PRODUCT CHANGE NOTIFICATION (PCN)

A-MCUP-80050/B MODULAR CABLE

PCN 20220425_A-MCUP-80050/B

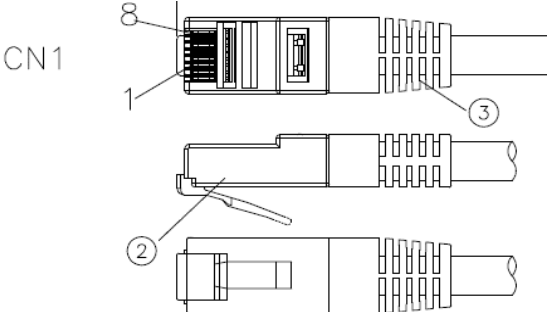
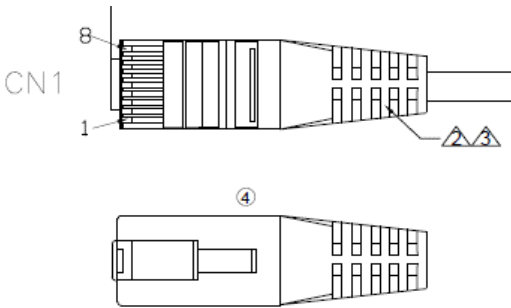
CHANGE OF DATA SHEET
CHANGE OF DATA SHEET
New Draw.-No. ASS_7407_CArev04

CHANGE OF PRODUCT LOCATION
CHANGE OF PRODUCT LOCATION

A-MCUP-80050/B		OLD VERSION		A-MCUP-80050/B		NEW VERSION	
Apprearence				Apprearence

BOM				BOM			
③	Molding PVC	2	Molding PVC 45P	④	Molding PVC	2	Molding PVC 65P
②	RJ45 CONN	2	RJ45 8P8C,Two Fork gold plated contacts 3u" gold	④	RJ45 CONN	2	RJ45 8P8C, contacts 3u" gold-plated Un-shielded PC UL94V-2
①	CABLE	1	UTP(26AWG*x1PR)*4+PVC OD:4.9±0.2mm	④	CABLE	1	CAT 5E U/UTP(26AWGx1PR)*4+PVC Jacket OD:4.9±0.2mm
NO.	NAME.	Q'TY	SPECIFICATION	NO.	NAME.	Q'TY	SPECIFICATION
FOR DETAIL, PLEASE TAKE ATTACHED NEW DRAWING: FOR REFERENCE
